MONITORING YEAR 4 ANNUAL REPORT

VILE CREEK MITIGATION SITE

Alleghany County, NC
DEQ Contract No. 5999
DMS Project No. 96582

RE: **Response to MY4 Draft Report Comments
Vile Creek Mitigation Project**
DMS Project # 96582
Contract Number 5999
New River Basin - HUC# 05050001 - Alleghany County, North Carolina

Recorded Geomorphic Significant Flow and Bankfull Events

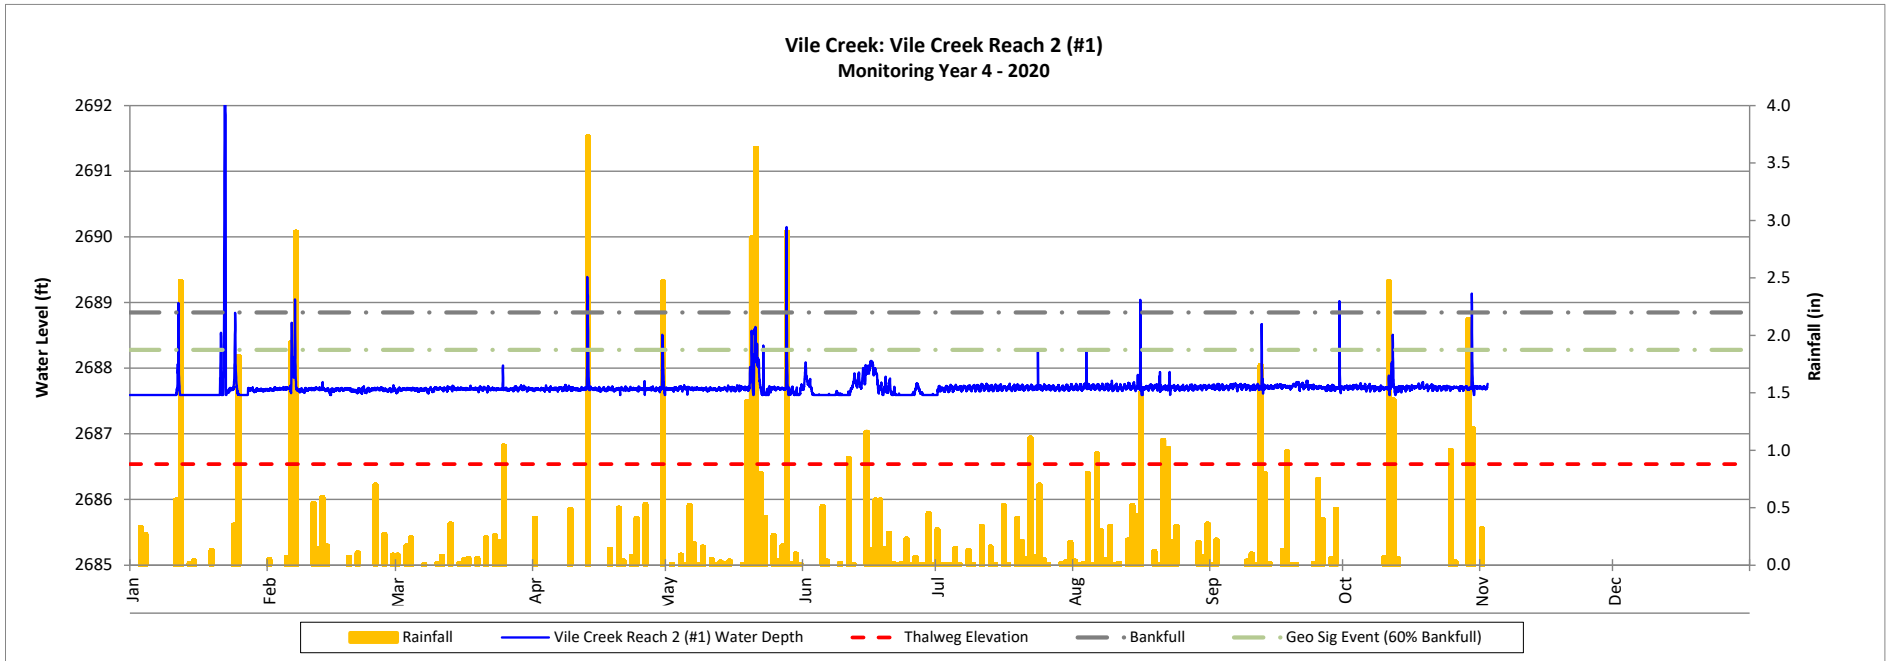
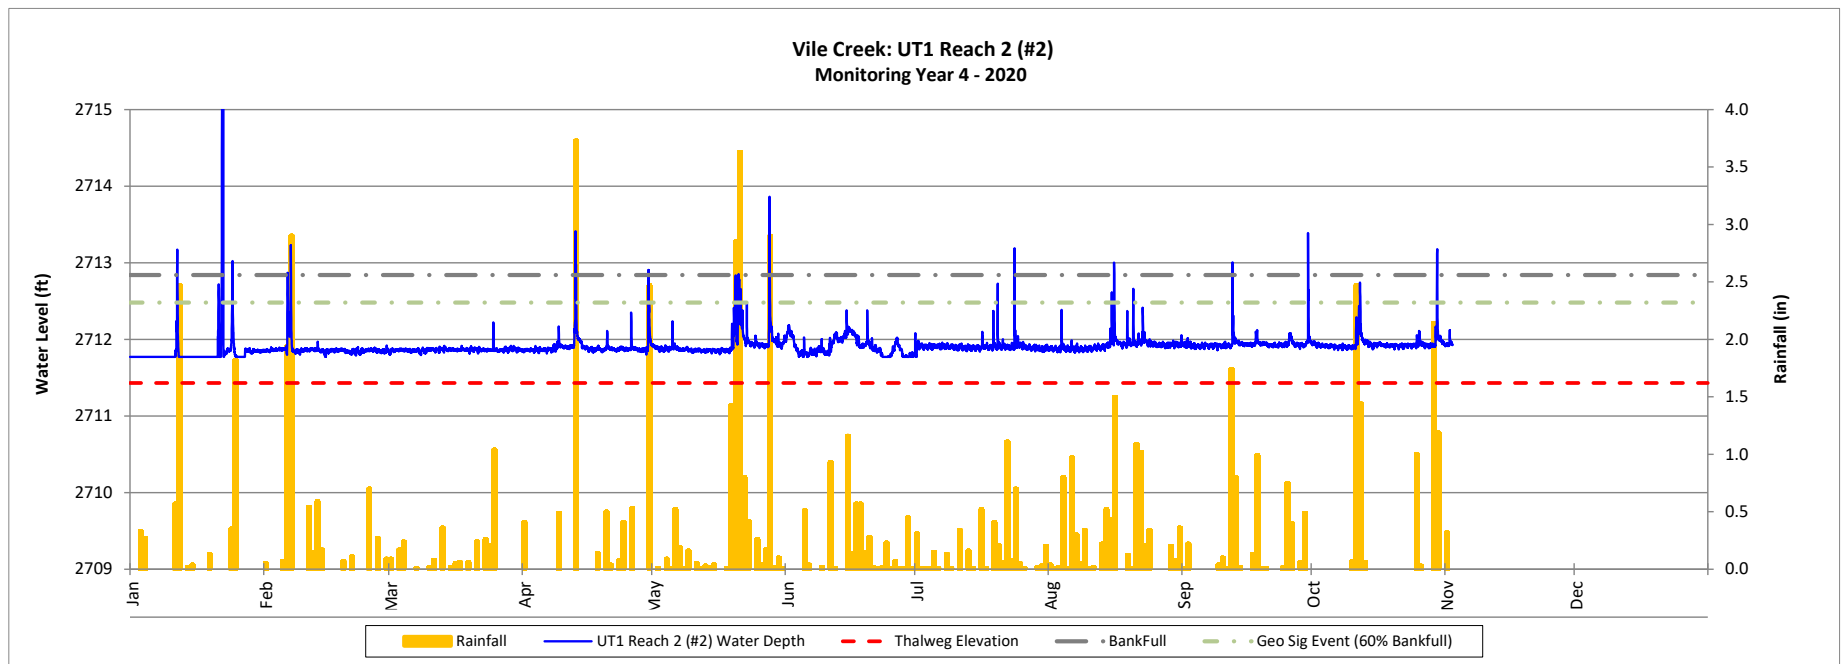
DMS Comment: Wildlands notes up to 12 bankfull events and up to 16 geomorphically significant events for 2020 across the site. While it was a wetter than normal year, is there an explanation of why such an unexpected number of apparent bankfull/geomorphic events occurred in 2020? Please consider confirming bankfull elevations in the field in MY5 due to so many recorded events.

Wildlands, response: The top of banks and eye bolt elevation were surveyed at each stream's crest gage during MY4. The crest gages were also resurveyed during the MY4 so a shift in elevation that effected the whole project during the monitoring year is unlikely. During the stream survey in MY5 and corresponding data will be adjusted if necessary, Wildlands will confirm bankfull elevations in the field. The only current explanation for the abundance of bankfull/geomorphic events that occurred in 2020 is the wetter than normal year. Wildlands' noted similar occurrences of above average bankfull/geomorphic events throughout most, if not all, of our NC monitoring projects during 2020.
